ARCHITECTURAL REVIEW BOARD MEETING

NOVEMBER 14, 2023 IN THE CITY COUNCIL CONFERENCE ROOM AT 5:00 PM

PLANNING AND ZONING COMMISSION CASE MEMO

TO: Planning and Zoning Commission
DATE: November 14, 2023
APPLICANT: Salvador Salcedo
CASE NUMBER: SP2023-032; *Site Plan for 855 Whitmore Drive*

D1 EAST ELEVATION
 1/8" = 1'-0"

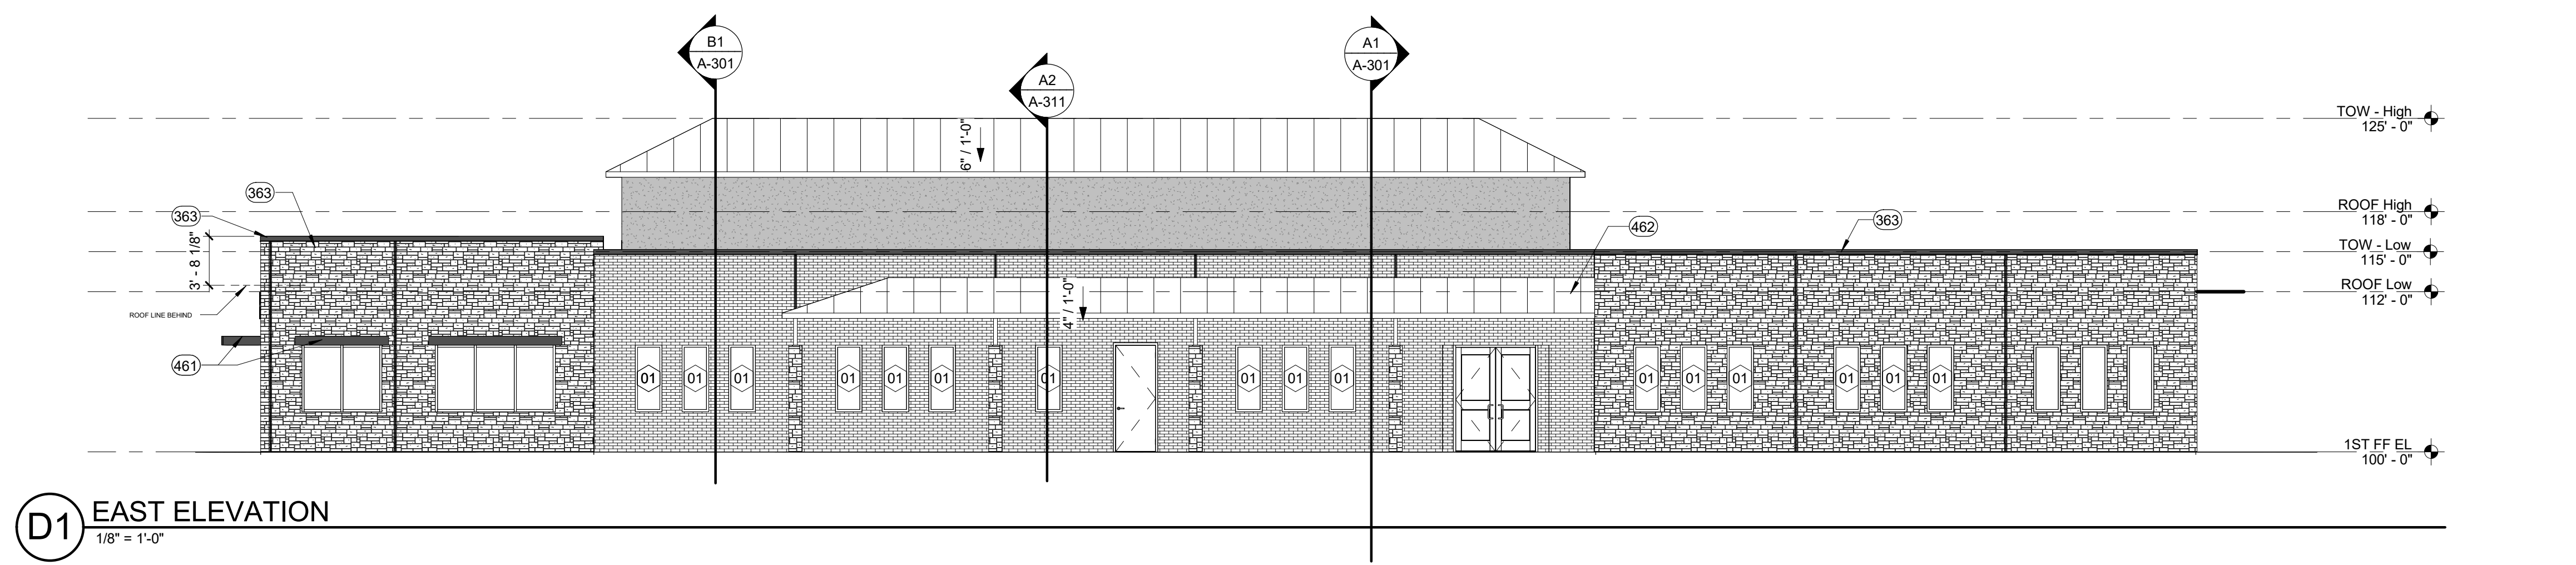
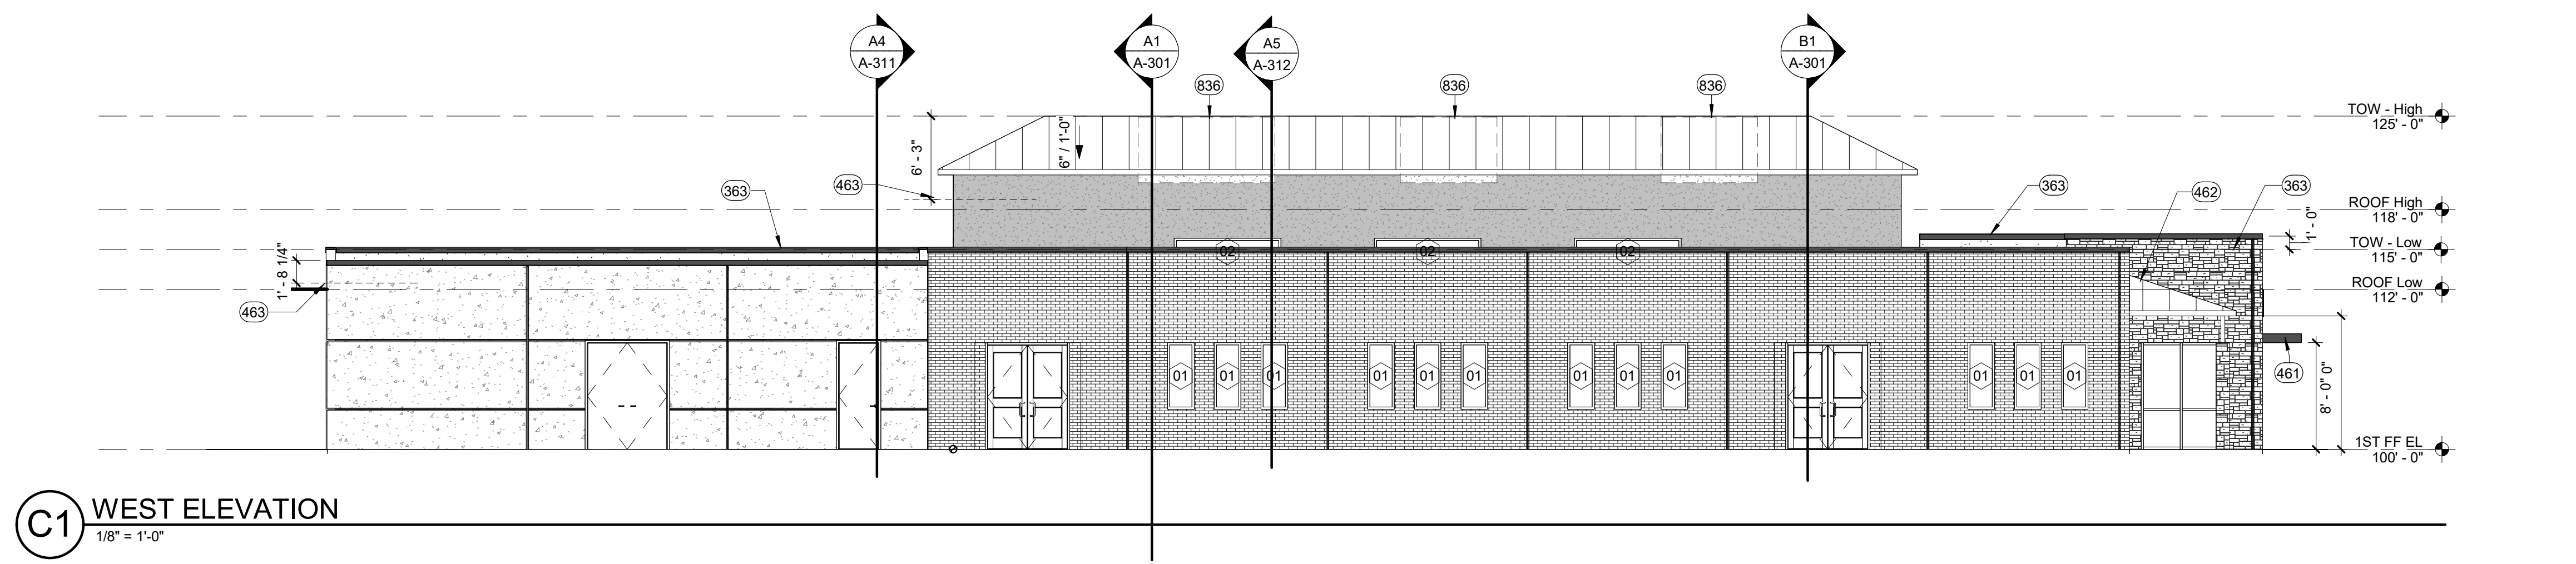
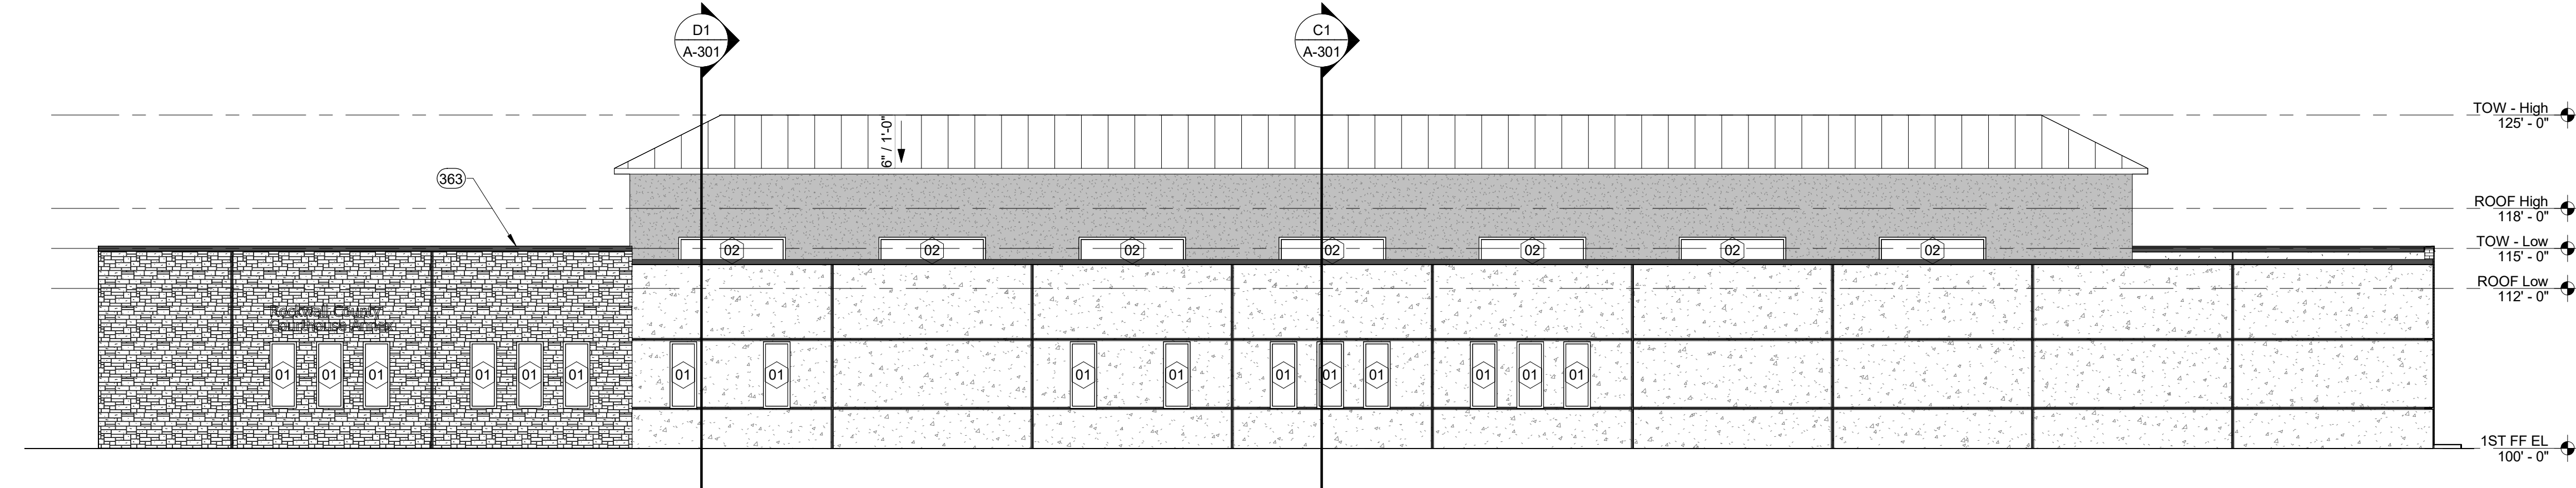
all four (4) sides utilizing the same materials, detailing, articulation and features.” In this case, the proposed building exceeds the wall length requirement, “...the maximum wall length shall not exceed three (3) times the wall height.” This will require a *variance* from the Planning and Zoning Commission pending a recommendation from the Architectural Review Board (ARB).

- (b) Stone. According to Subsection 06.02(C)(1)(a)(1), *General Overlay District Standards*, of Article 05, *District Development Standards*, of the Unified Development Code (UDC), “(a) minimum of 20.00% natural or quarried stone is required on all building façades.” In this case the applicant has not met this requirement on the north and west building façades. This will require a *variance* from the Planning and Zoning Commission.

- (c) Masonry Material. According to Subsection 06.02(C)(1)(a)(1), *General Overlay District Standards*, of Article 05, *District Development Standards*, of the Unified Development Code (UDC), a minimum of 90.00% masonry material must be utilized on each building façade. In this case the applicant has not met this requirement on the north and west building façades. This will require a *variance* from the Planning and Zoning Commission.

- (d) Tilt-Up Wall. According to Section 06.01(C)(1), *General Overlay District Standards*, of Article 05, *District Development Standards*, of the Unified Development Code (UDC), concrete tilt-up walls are not a permitted material. The applicant is proposing the use of tilt-up wall construction for the building, and the amount of exposed tilt-up wall is 24.90% (*on the west building elevation*) and 58.60% (*on the north building elevation*). This will require a *variance* from the Planning and Zoning Commission.

- (e) Roof Pitch. According to Subsection 04.01(A)(1), *General Commercial District Standards*, of Article 05, *District Development Standards*, of the Unified Development Code (UDC), “(a)ll structures shall have the option of being constructed with either a pitched (*minimum of a 6:12 roof pitch*), parapet, or mansard roof system as long as the roof system is enclosed on all sides.” In this case, the applicant is doing a pitched roof system where the canopies have a 4:12 pitch. This will require an *exception* from the Planning and Zoning Commission.

On November 1, 2023 the Architecture Review Board (ARB) reviewed the building elevations provided by the applicant. The ARB requested the applicant provide a material sample board and provide material variation on the north and west facades. The applicant has made the requested changes on the north façade, which will be reviewed by the ARB prior to the November 14, 2023 meeting.
